SUBJECT: Single Phase, 4800 Volt Distribution line  
Reference No: 06654291/Sage/Gladwin/Hall

Subject: **UGL071131/CU-255**  
06654291/Sage/Gladwin/Hall  
Single Phase, 4800 Volt Distribution Line Pole Attachment

# NOTIFICATION OF PROPOSED LINE CONSTRUCTION REQUIRING COORDINATION WITH HVD AND/OR TRANSMISSION LINES

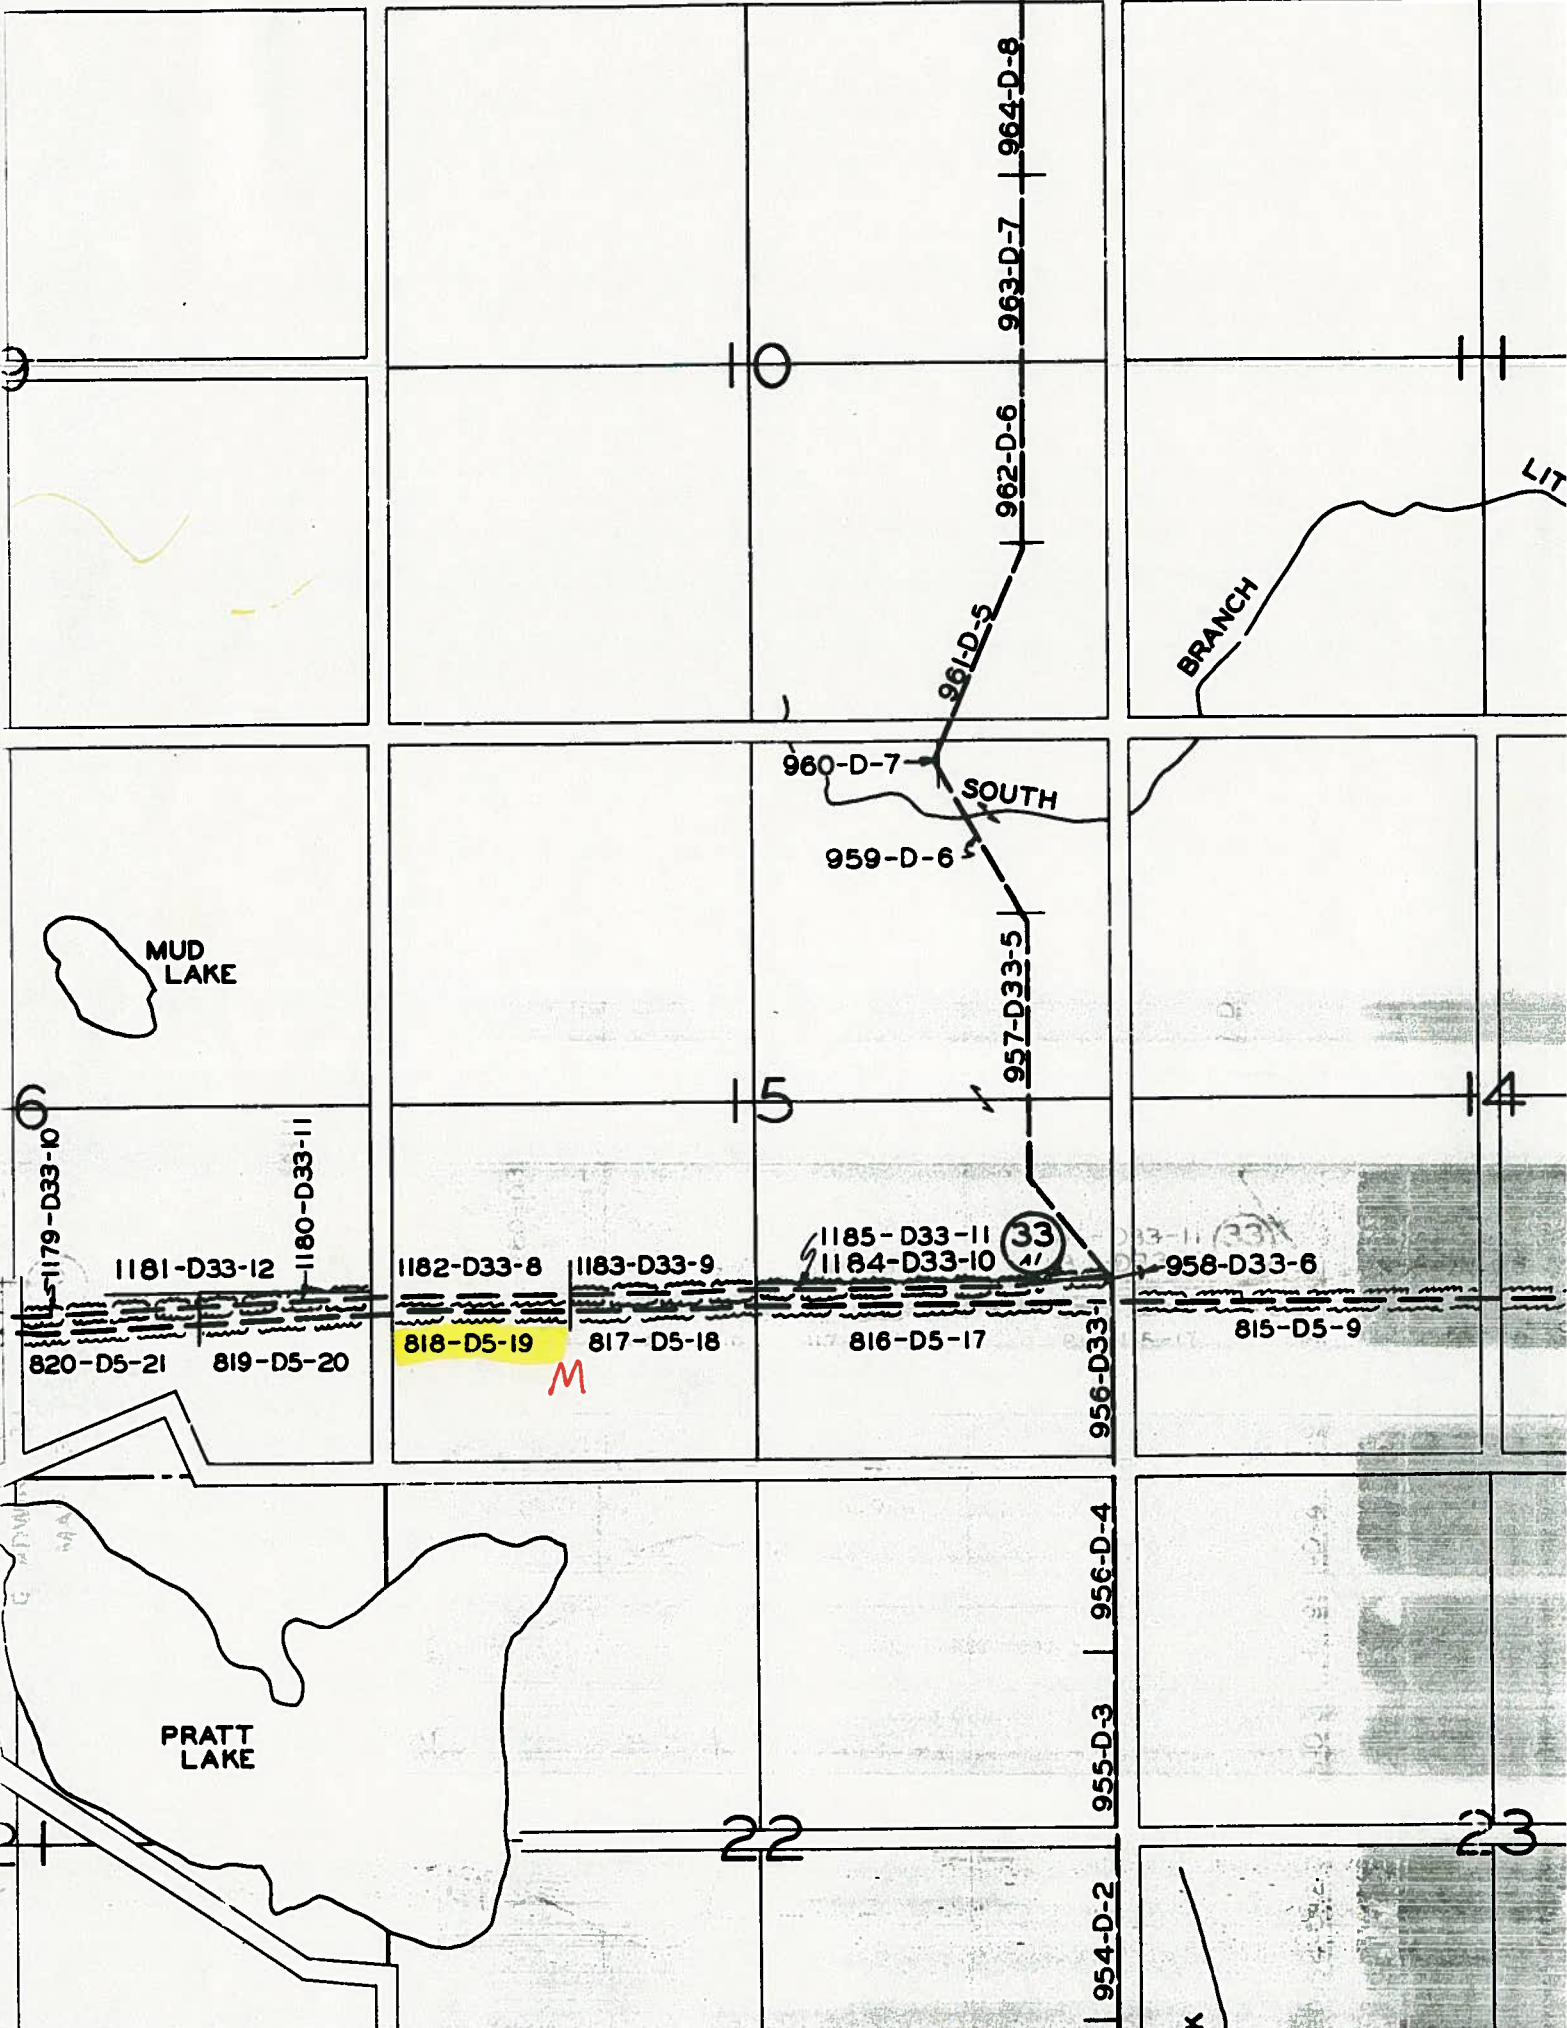
**Install a distribution line. New distribution will cross under an existing transmission line. The distance below transmission is 10 feet. See attached 391 form, drawing, and plan and profile for details.**

Distance Below Transmission 10'

Transmission Line Involved Gallagher Bard Rd Line

Transmission Pole No. 1005

This request is hereby approved

**METC lines are subject to the easement rights of METC. Your request has been forwarded to Real Estate for processing and will require a 30-day period prior to approval.**
